**REMARKS**

a) As defined in the preamble to claim 1, the claims of the present invention describe a method of measuring the chromatic dispersion of an optical link. The claims as amended now

FIGURE 1A

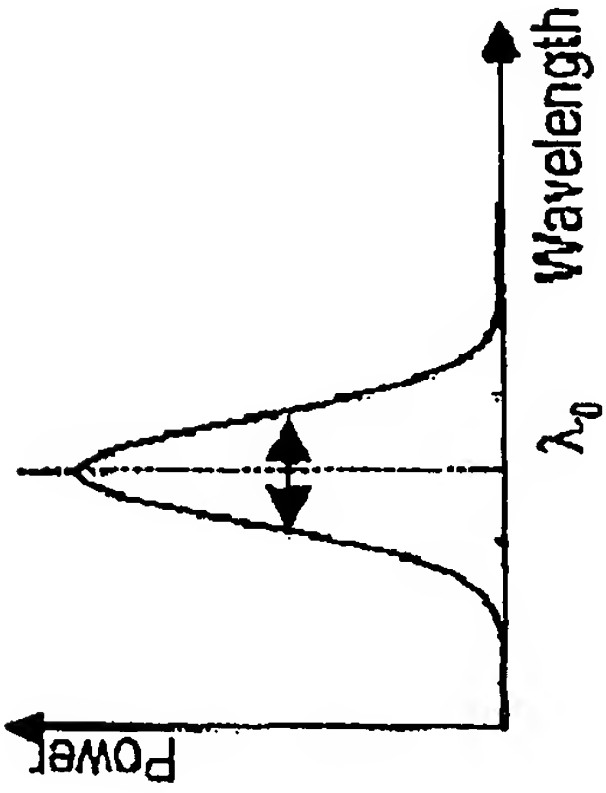
FIGS. 1A, 1B and 1C have been amended as required by the Examiner. Corrected formal drawings will be filed upon allowance of the Application.
